Access Compliance Report

Public Rights-of-Way

(Curb Ramps)

Intersection ID: 28003	Main Street: COMMUNITY_HOUSE_RD	Cross Street: WILLOW_ROCK_DR	Location: SW
ADA ID: F644CACF3727	Ramp Type: BlendTrans2	Initial Pass/Fail: Fail	Overall Compliance: No
Severity Score: 1.25			
Codes/Mitigation Info/Possible Solution		Field Measurements/Component Compliance

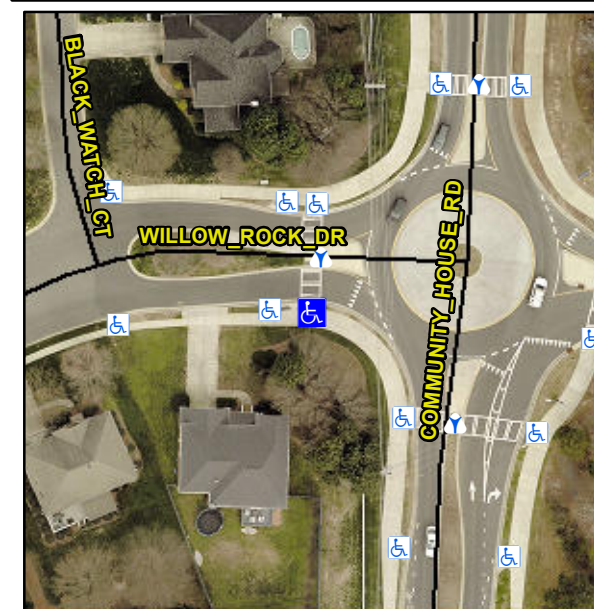
R304.5.3

Compliance	Description	Data	Compliance	Description	Data
N/A	Ramp Length (in)	143.0	Yes	BlendTrans Slope (%)	2.6
Yes	Ramp Width (in)	84.0	No	BlendTrans XSlope (%)	3.4
N/A	Flare Type LT	N/A	N/A	Flare Type RT	N/A
N/A	Flare Slope LT (%)	N/A	N/A	Flare Slope RT (%)	N/A
N/A	Flare Traversable LT?	N/A	N/A	Flare Traversable RT?	N/A
N/A	Landing Length (in)	N/A	N/A	DWS Provided?	N/A
N/A	Landing Width (in)	N/A	N/A	DWS Contrast?	N/A
N/A	Landing Slope (%)	N/A	N/A	DWS Length (in)	N/A
N/A	Landing X Slope (%)	N/A	N/A	DWS Full Width?	N/A
N/A	Landing Curb? (Y/N)	N/A	N/A	DWS Offset (in)	N/A
N/A	Shared Landing?	N/A			
N/A	Gutter Ponding?	N/A	N/A	Gutter Slope (%)	N/A
N/A	Gutter Lip Ht (in)	N/A	N/A	Gutter X Slope (%)	N/A
N/A	Painted X Walk1?	Yes	N/A	Painted X Walk2?	N/A
	X Walk 1 Direction	To N		X Walk 2 Direction	N/A
	X Walk 1 Width (in)	128.0		X Walk 2 Width (in)	N/A
	X Walk 1 Slope (%)	2.5		X Walk 2 Slope (%)	N/A
	X Walk 1 X Slope (%)	2.9		X Walk 2 X Slope (%)	N/A

Remove & Replace Curb Ramp With Two New Directional Ramps or Equivalent.
